C-2-1 Assessment for Representative Person and Reference Animals and Plants

IAEA Regulatory Review Mission on ALPS Treated Water Handling

23 March 2022

vi. Potential Exposure

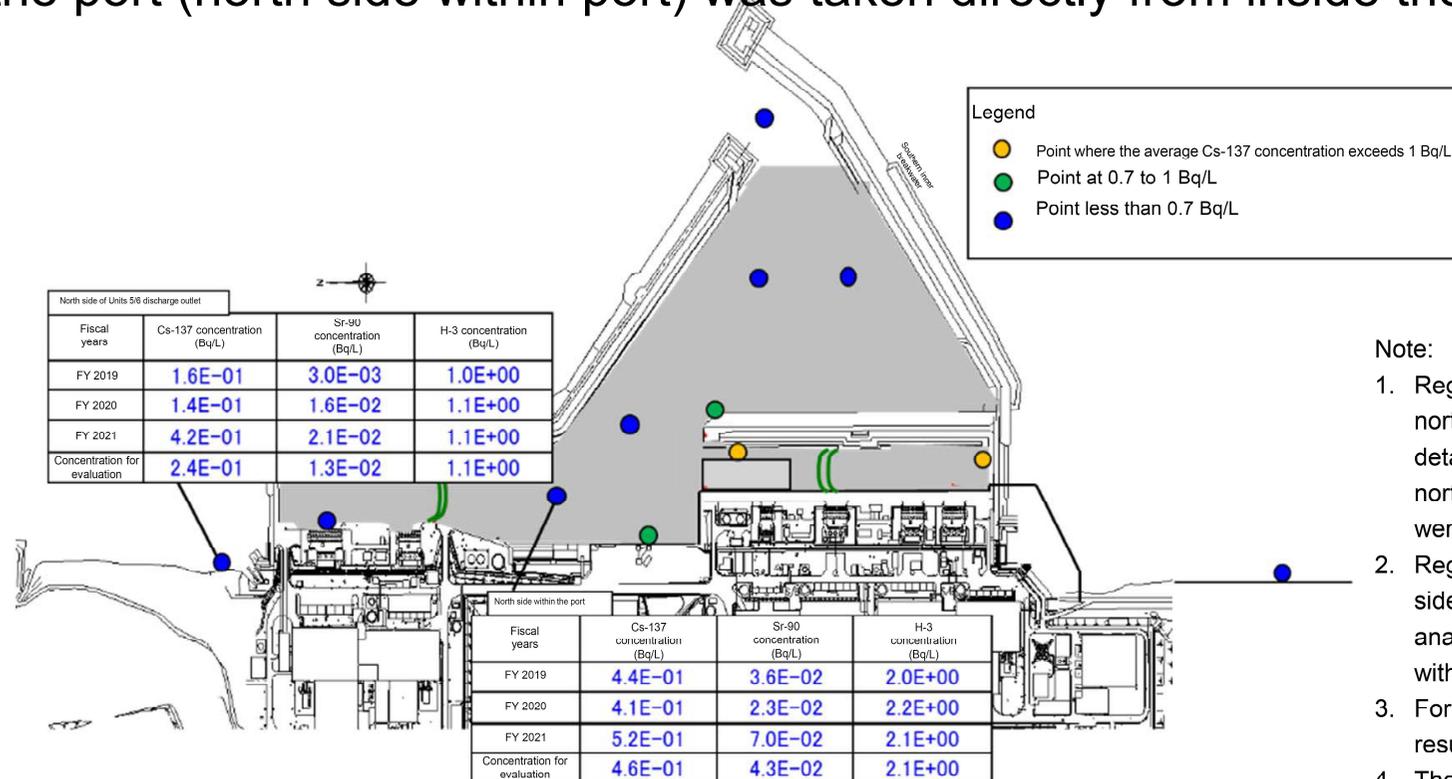
TEPCO should explain the concept of the assessment which does not follow the flow shown in Fig. 3 of GSG-10, including the basis for selection of the scenario.

- TEPCO reorganized the exposure pathways for potential exposure
- New exposure pathways listed below were added
 - External and internal exposure during underwater work, external exposure from ship hulls, beaches, and fishing nets, and internal exposure from ingestion of marine products
- Dose assessment results increased from 10^{-5} to 10^{-1} order of magnitude. However, they were still below the dose criterion of 5 mSv.
